Model: V-C2 Color Controller E-7100	Date: 23-Jun-08	No.: MD380001a
-------------------------------------	-----------------	----------------

RTB Reissue

Part Change Information List

Modified Article: Cable		Prepared by: C. Tsuji	
From: 2nd Tech. Support Sec. Service Support Dept.			
Reason for Modification:	☐ Parts catalog correction	☐ Vendor change	☐ Other
	☐ To facilitate assembly	☒ To improve reliability	☐ To meet standards
	☐ Part standardization	☐ Product Safety	()

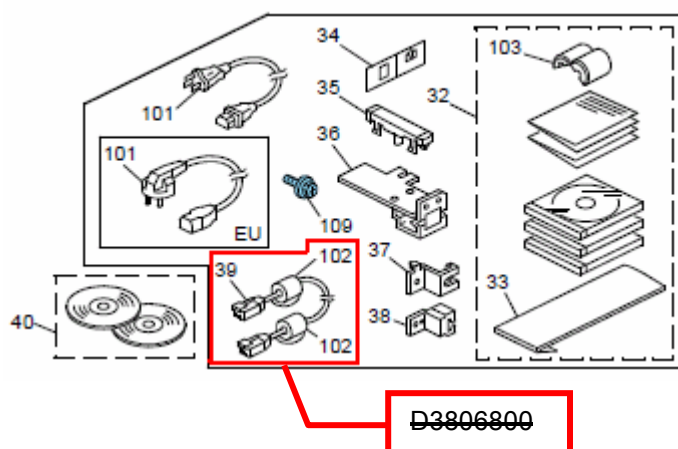
***The cable and ferrite core will still be provided separately as spare parts.
The following information was entirely wrong.***

Old part number	New part number	Description	Q'ty	Int	Page	Index
D3775854	=	CABLE:NIC:3M:GIGA	1-0	=	2	39
16071464	=	FERRITE CORE:RFC 13	1-0	=	2	102
=	→ D3806800	CABLE:NIC:3M:GIGA:ASS'Y	0-1	=	2	42

~~Change:~~ The cable and ferrite core were combined into one service part.

~~Reason:~~ The vendor only provides the cable and ferrite core as an assembly.
